UNITED STATES PATENT AND TRADEMARK OFFICE

Office Action Summary	Application No. 10/559,533	Applicant(s) OKIYAMA, TADASHI	
	Examiner SHEFALI D. PATEL	Art Unit 3767

DETAILED ACTION

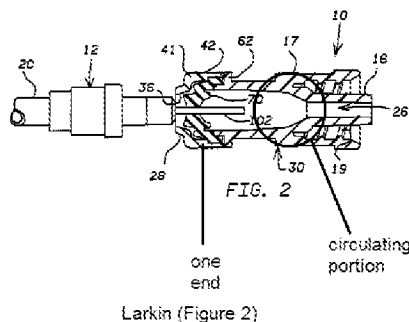
In regards to claims 1, 15, and 16, Larkin teaches an injection port (Figures 1-3) in which one end (*labeled in Figure 2 below*) of a channel tube (connector [10]) is covered by a septum (seal [70]) provided with a slit (slit [74]) into which a tube member (cannula assembly [12]) is

inserted, wherein the channel tube [10] is provided with a circulating portion/path (*labeled in Figure 2 below*).

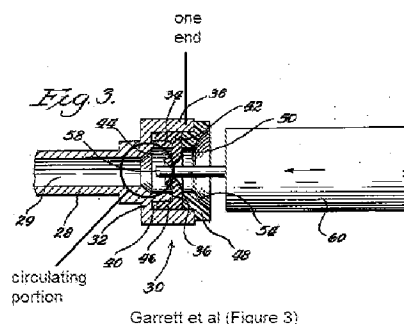
In regards to claims 1, 15, and 16, Garrett et al teaches an injection port (Figures 3-4) in which one end (*labeled in Figure 3 below*) of a channel tube (closed irrigation site [30]) is

covered by a septum (membrane [42]) provided with a slit (slit [56]) into which a tube member (syringe [60]) is inserted, wherein the channel tube [30] is provided with a circulating portion/path (*labeled in Figure 3 below*).

In regards to claims 21 and 22, Garrett et al teaches a method for transferring a fluid to or from a body through a mixture injection port (Figures 3-4), the mixture injection port comprising a channel tube [30] with an end (*labeled in Figure 3 above*) that is covered by a septum [42] that is provided with a slit [56], the method comprising:

Wiltse (Figure 2)

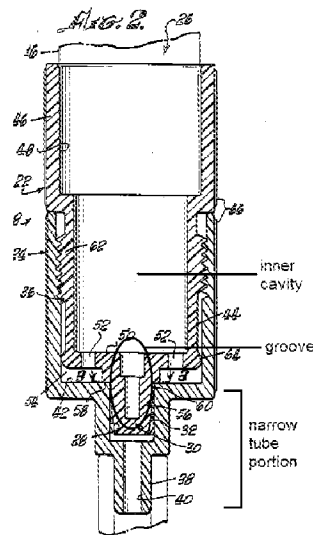
Larkin does not teach that the circulating portion comprises a circulating-plate portion. Wiltse teaches an injection port (Figure 2, valve [18]) having a channel tube (outer valve parts [22][24]) with a circulating-plate portion (flow metering valve plug [30]) mounted on a step (wall surface [42]) between the inner cavity (*labeled in Figure 2 below*) and the narrow tube portion (*labeled in Figure 2 below*). The circulating-plate portion also has a groove (*labeled in Figure 2 below*) on the surface of its inner cavity side, a holding portion (valve plug end [56]) engaged with the narrow tube portion, and a groove (flow slots [32]) on its back face. It would have been obvious to a person having ordinary skill in the art at the time the invention was made to incorporate a circulating-plate portion, as taught by Wiltse, onto the circulating portion of an injection port of Larkin, as the circulating-plate portion will enable the user to regulate and block fluid flow through the injection port based on the fluid needs of the patient (column 2, lines 45-55).

Wiltse teaches an injection port (Figure 2, valve [18]) having a channel tube (outer valve parts [22][24]) with a circulating-plate portion (flow metering valve plug [30]) mounted on a step (wall surface [42]) between the inner cavity (*labeled in Figure 2 above*) and the narrow tube

portion (*labeled in Figure 2 above*). The circulating-plate portion also has a groove (*labeled in Figure 2 above*) on the surface of its inner cavity side, a holding portion (valve plug end [56]) engaged with the narrow tube portion, and a groove (flow slots [32]) on its back face. It would have been obvious to a person having ordinary skill in the art at the time the invention was made to incorporate a circulating-plate portion, as taught by Wiltse, onto the circulating portion of an injection port of Garrett et al, as the circulating-plate portion will enable the user to regulate and block fluid flow through the injection port based on the fluid needs of the patient (column 2, lines 45-55).

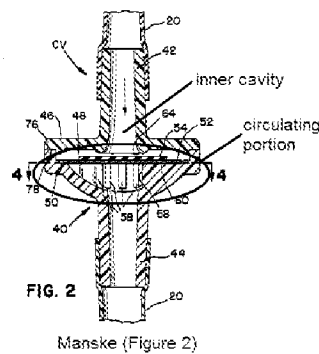
Larkin does not teach that the circulating portion comprises a circulating-plate portion. Manske teaches a valve (Figure 2) with a circulating portion (*labeled in Figure 2 below*) which has a circulating-plate portion (screen [52]) that is mounted on a step (shoulder [50]) generated between the inner cavity (*labeled in Figure 2 below*) and the narrow tube portion (outlet [44]). It

In regards to claims 6 and 7, Larkin does not teach a protruding edge portion or a groove on the circulating portion. Manske teaches a circulating portion (*labeled in Figure 2 above*) with edge portions (Figure 4, ribs [58]) and grooves, situated between the ribs [58]. It would have been obvious to a person having ordinary skill in the art at the time the invention was made to modify the circulating portion of Larkin with edge portions and grooves, as taught by Manske, in a modified injection port of Larkin and Manske, as the structure of the edge portions and grooves of the circulating portion will function to guide fluid flow through the injection port and out into the patient's body through the outlet (column 3, line 68 to column 4, lines 1-2).
